We thank the Referee #2 for his/her comments and suggestions. They will help improve the manuscript. We will address comments in the order discussed by the Referee starting with "General comments". In the following Referee's comments are in black, replies in blue and modifications of the manuscript we propose in green. New phrases added to the text are underlined.

GENERAL COMMENTS

Fig.R1: (a) the observed water table depth in the Netherlands, taken from the Fan et al., (2013), supplementary material; (b) wetlands in GLWD; (c) RFW map; (d) CW-WTD. The percentages in each window show the ratio of wetlands' area to Netherlands's surface area.

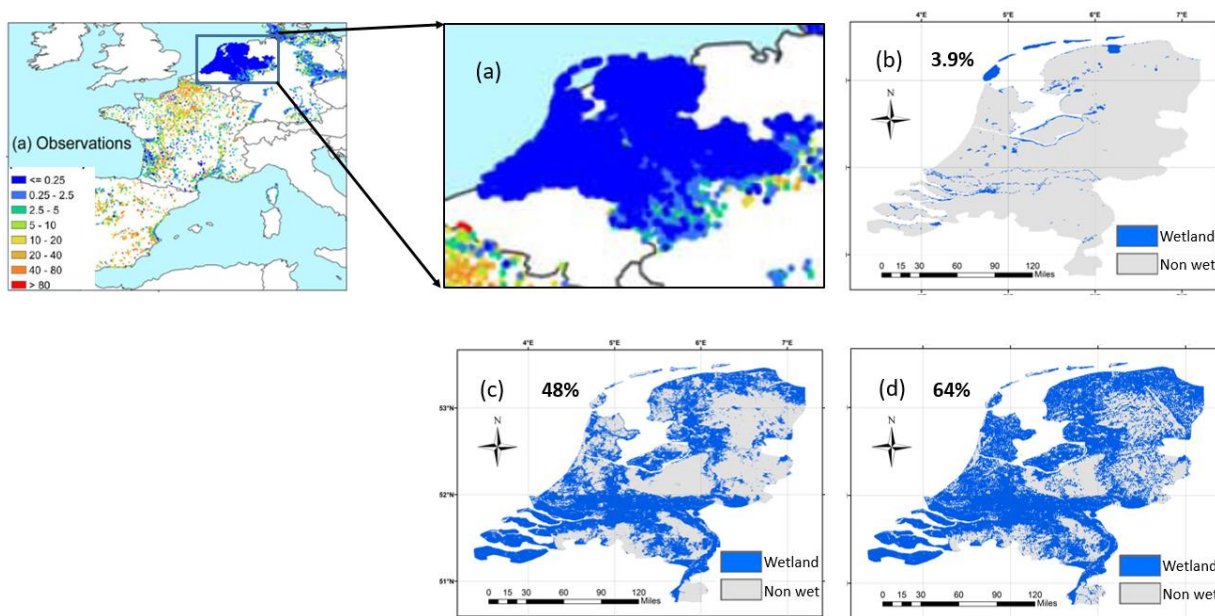
Regarding 1) the work of Adam et al. 2010 indicates that GIEMS overestimates inundation area in the Netherlands and Northern Germany and more so in India (if rice-paddies are taken into account), likely due to confounding wet soils with inundated areas. This was later supported by unpublished work (Master thesis of Matthias Konig). Here, the author compared Landsat ETM+ scenes with GIEMS and found a strong overestimation of inundation extent by GIEMS in Ganges-Brahmaputra and Parana river basins during and after months with more than 100 mm rainfall. Evaluating the presented RFW map for the Netherlands

and northern Germany (around Hamburg), I do not find it realistic that so many km² of land area inundated on average in one out of twelve months. I suggest providing the dataset on Google Earth such that the validity/uncertainty of the data set can be judged more easily based on local knowledge about e.g. the mean annual maximum extent of inundation that was predominantly used to produce RFW.

For example, over the Netherlands (mentioned by referee#2), 21% of the country's land surface area is recognized as Ramsar wetland sites (more than 9000 km²). These sites are the ones under international protection and it is not surprising to have 48% of the country's land surface covered by wetlands in RFW map, since many wetland sites are not recognized in Ramsar convention or are small in size. Moreover, based on maps of observed water table depth, the groundwater level is almost at the surface for most of the Netherlands Fig.R1a. This is in contrast with the wetlands in GLWD with only less than 4% coverage of the country. It appear as the RFW and CW-WTD (Fig.R1c,d) capture significantly better the pattern of shallow water table depths all over the Netherlands, in particular coastal wetlands from Rotterdam in the north to the Westerschelde estuary in the south.
